Project: North Cove Cellular Steel Sheet Pile Encasement **Date:** 11/13/15

Engineer: McLaren Engineering Group **RE:** Addendum #2
of Pages: 9 pages

The following revisions and/or clarifications are to be made to the Request for Proposals for “North Cove Cellular Steel Sheet Pile Encasement.” They are a result of issues discussed at the pre-proposal conference held on October 28, 2015, inquiries made by prospective proposers and additional requirements imposed by BPCA.

PROJECT NO. 140950.09	
SCALE AS NOTED	
DATE 10/15/15	
DRAWN BY CFA	
CHECKED BY SLS	
DRAWING NO. S-132	
5 OF 6 SHEETS

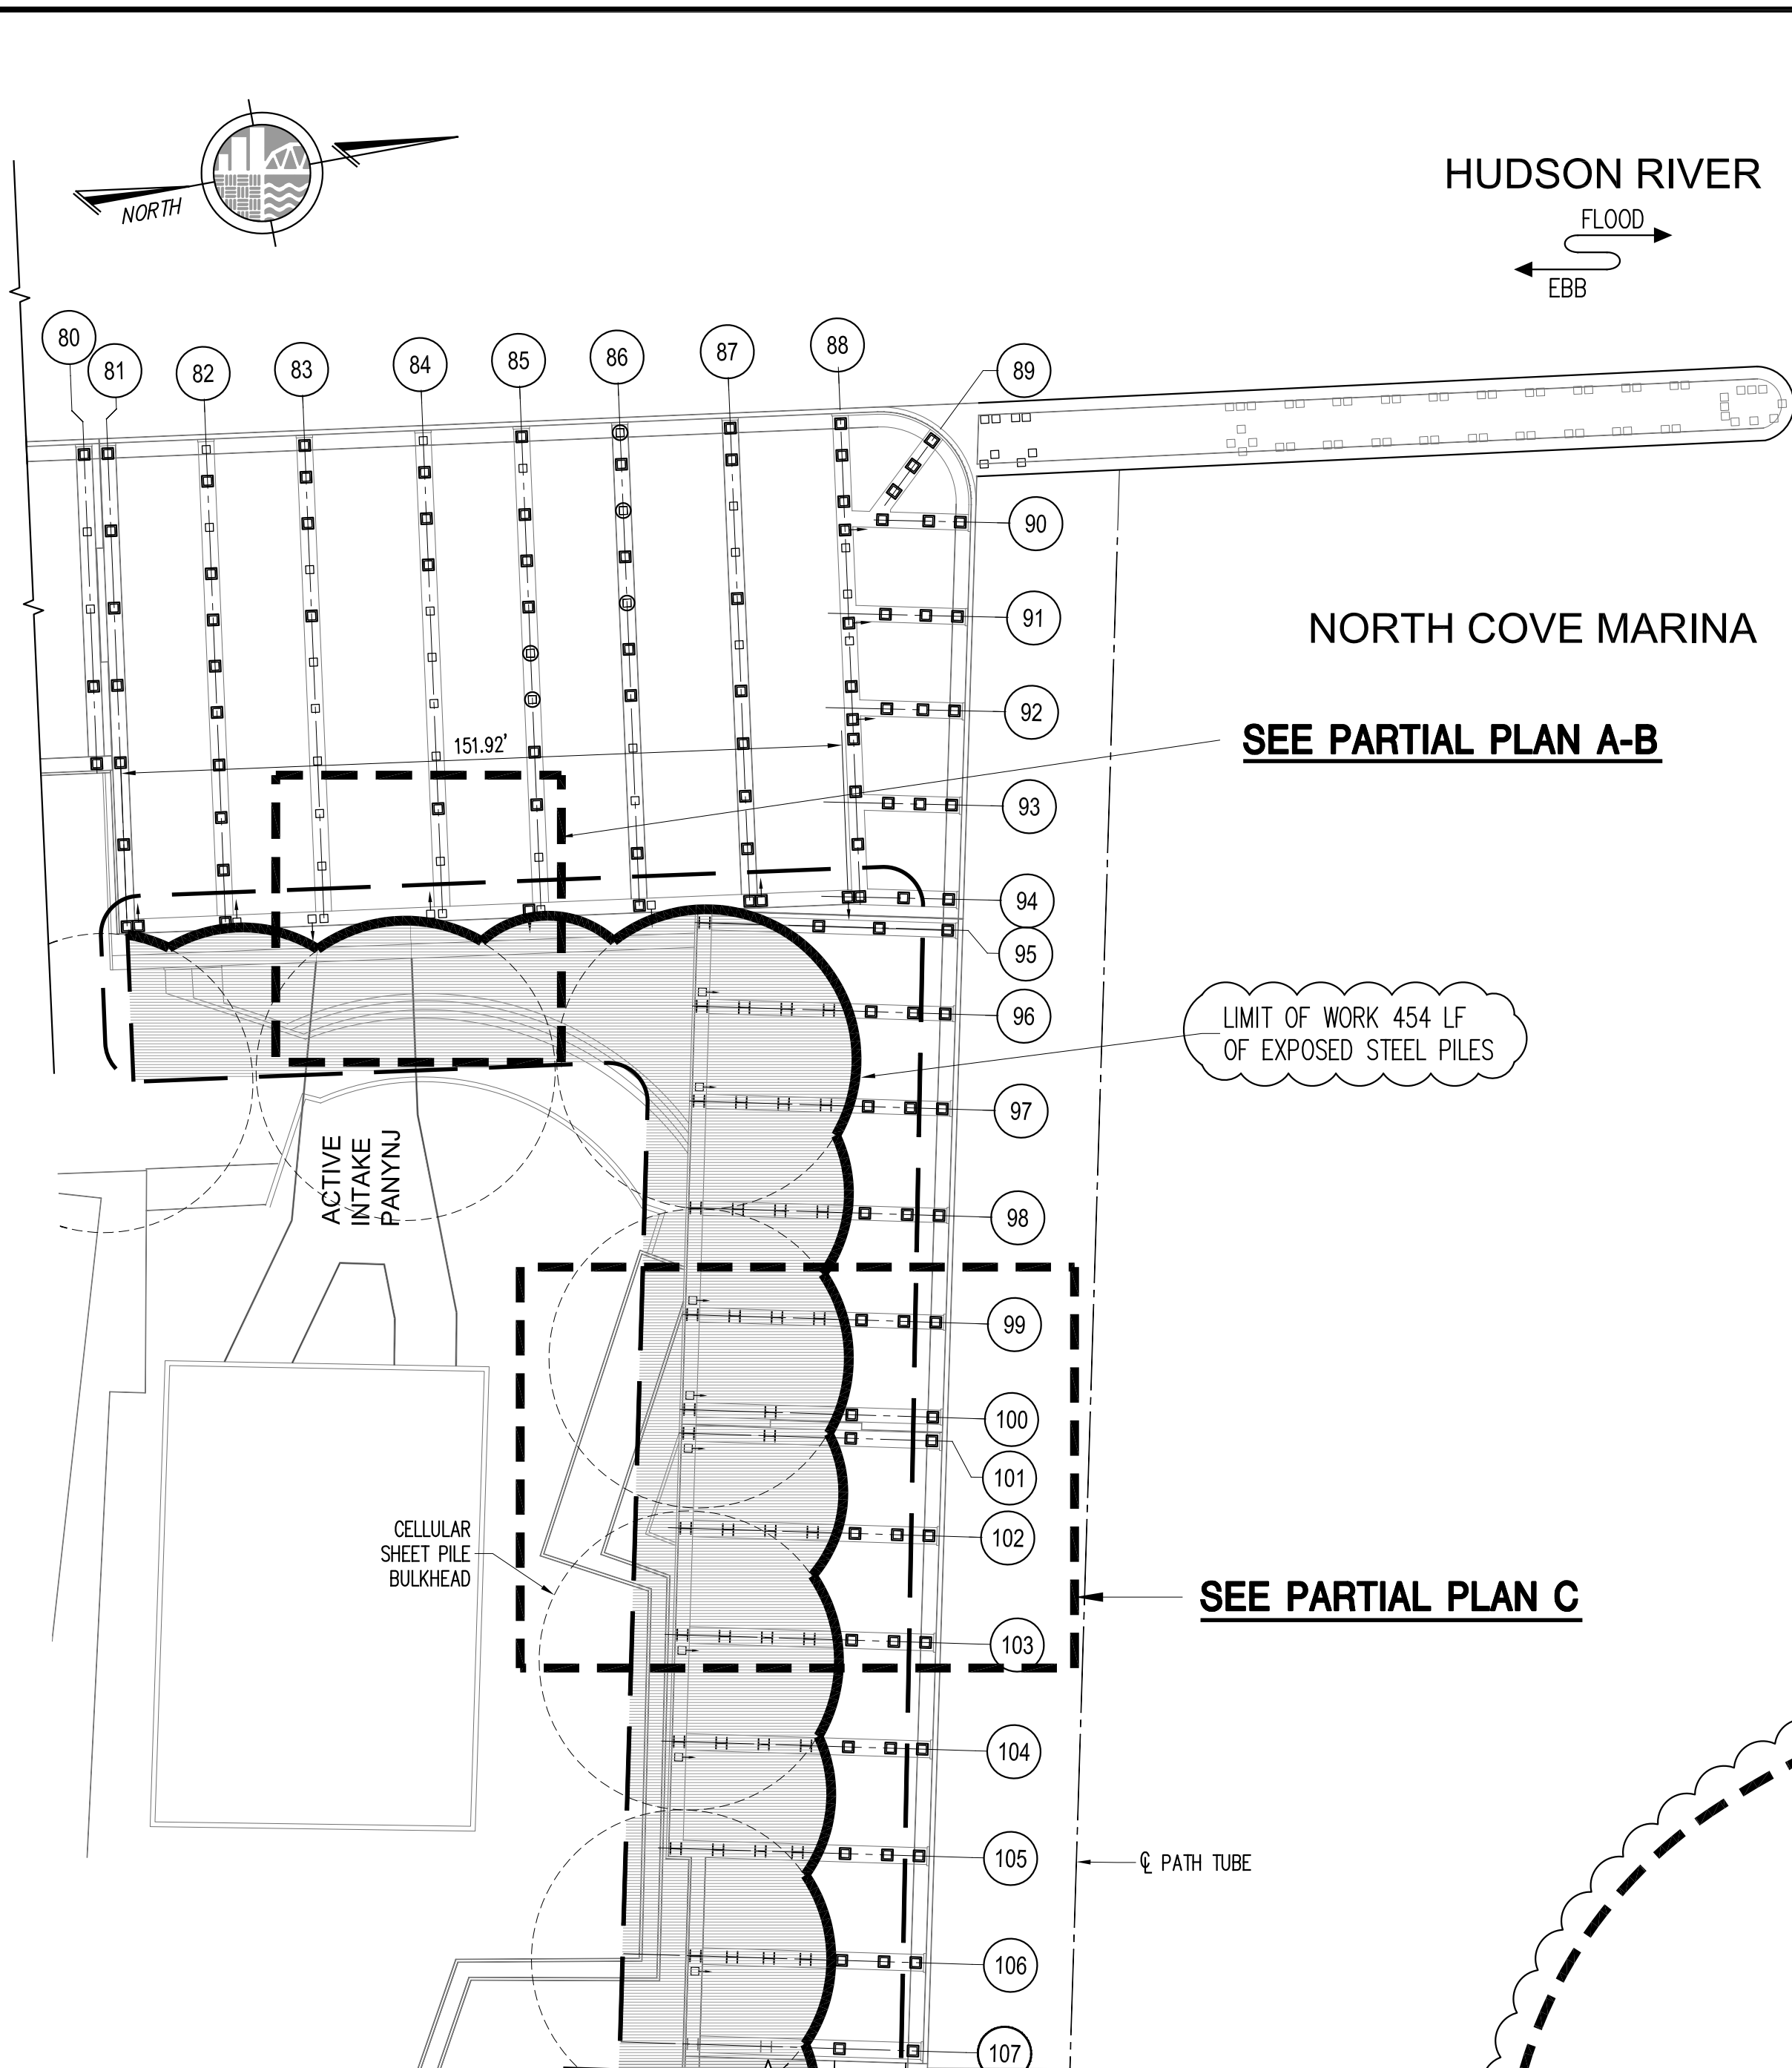
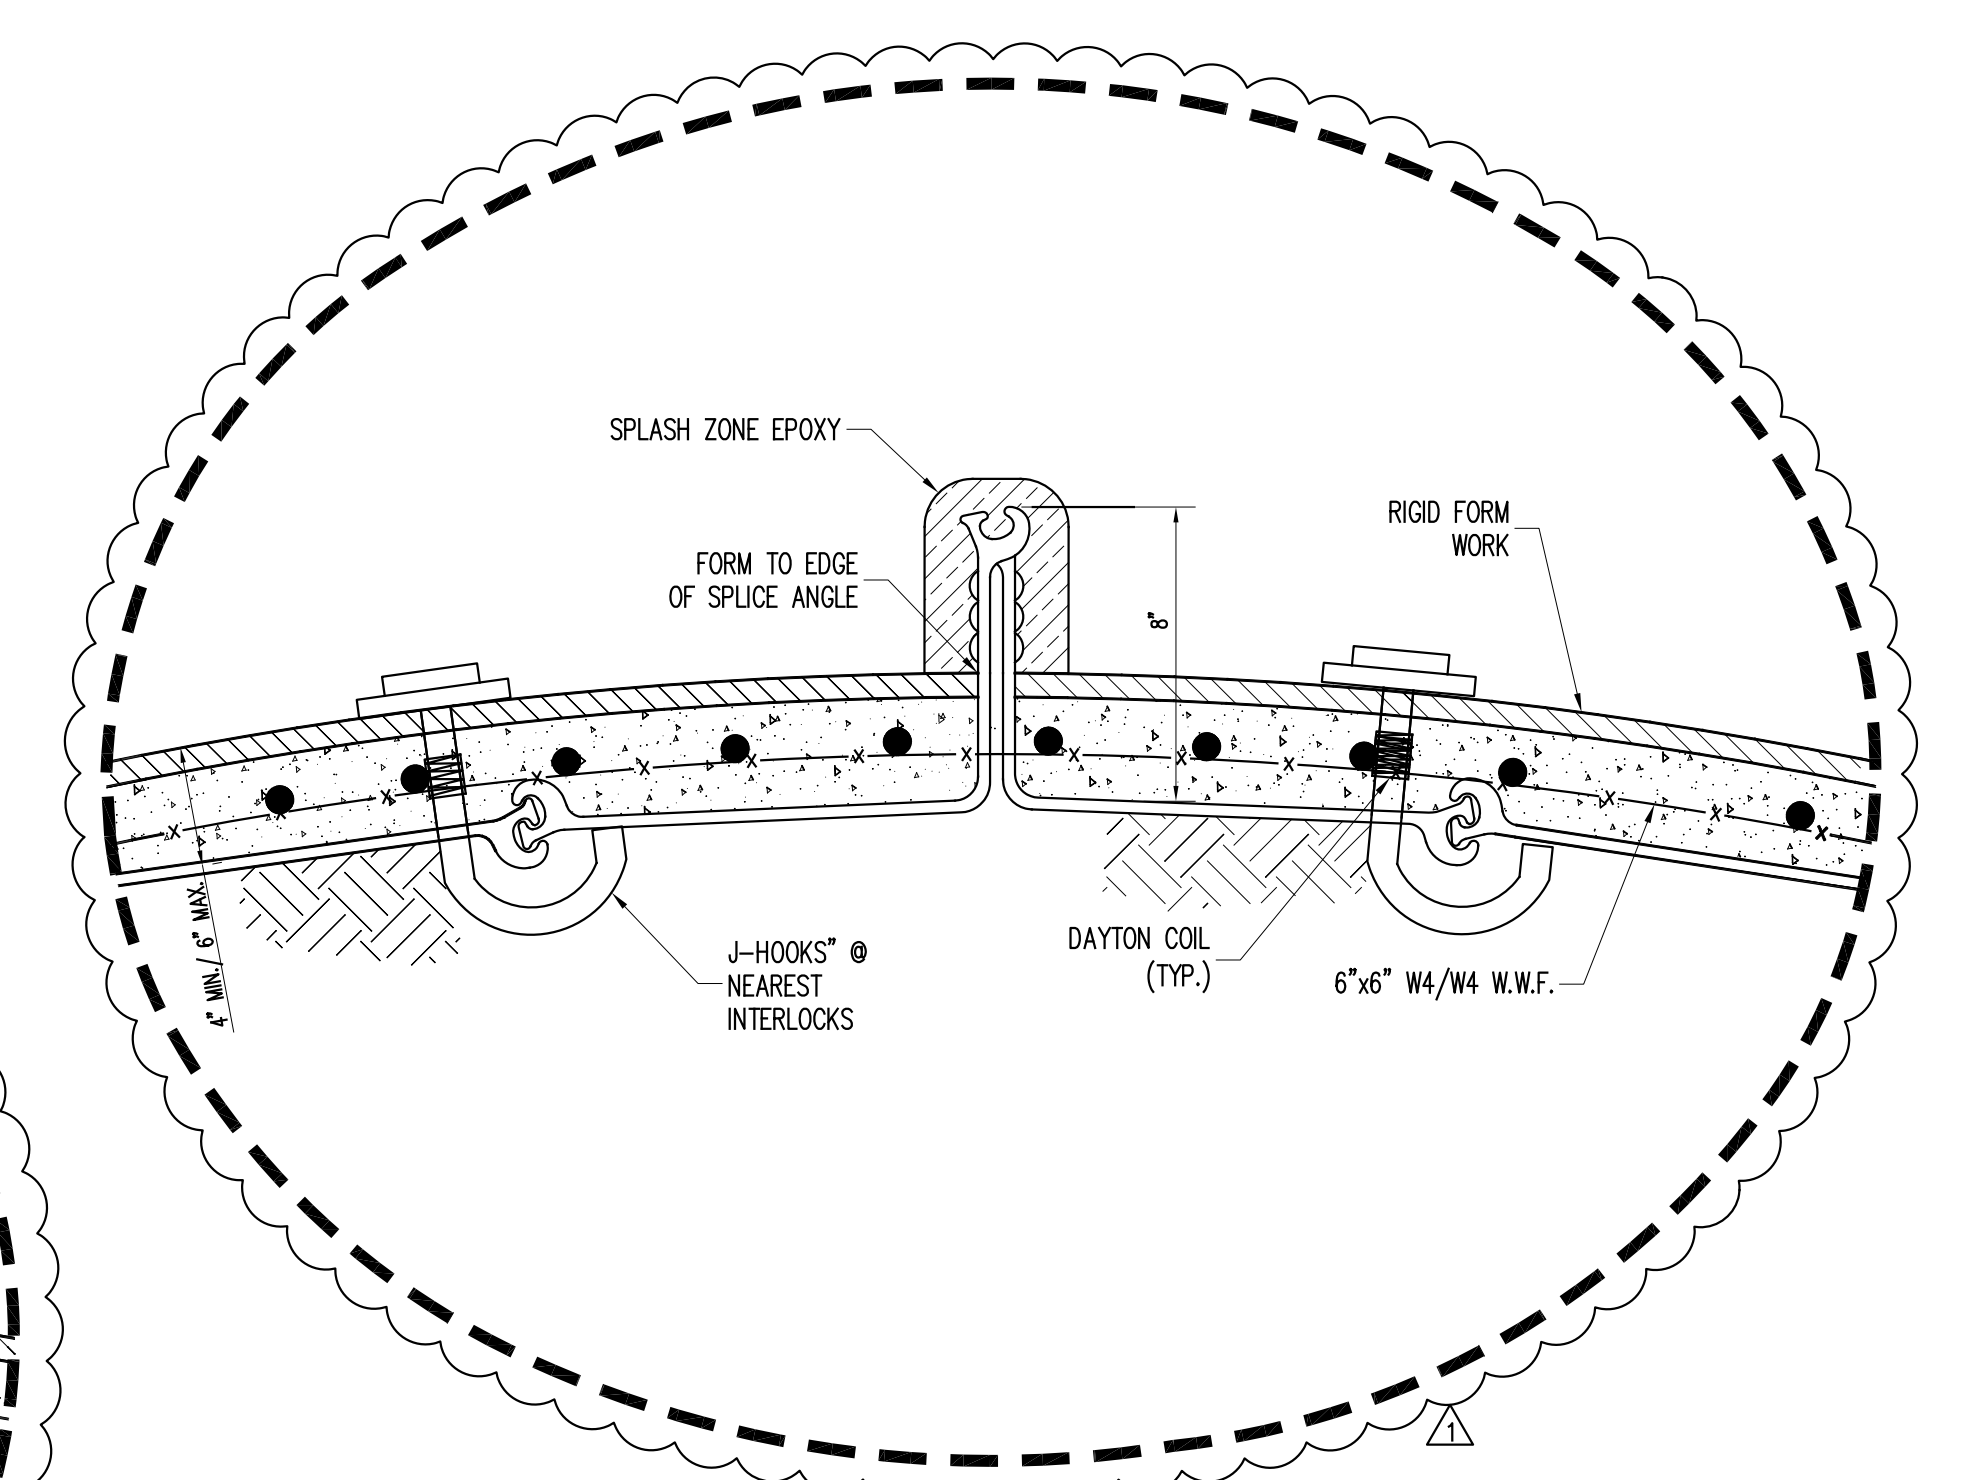
1 - Repair plan on S-132 refers to a continuation on S-133. This drawing is missing.

2 - Section C on S-140. Where is this section taken from?

4 - Section F and G on S-140 refer to Detail A on S-132. There is no detail A on S-132.

The scope of work terminates at Bent 107 inside the Path Tunnel, therefore, Drawing S-133 is not necessary for this bid. Please disregard that continuation sheet.

C/S-140 is taken from a cross section on Partial Plan C, Sheet S-132 as corrected in the drawings Revision No. 1 (attached).

See response to Question 2.
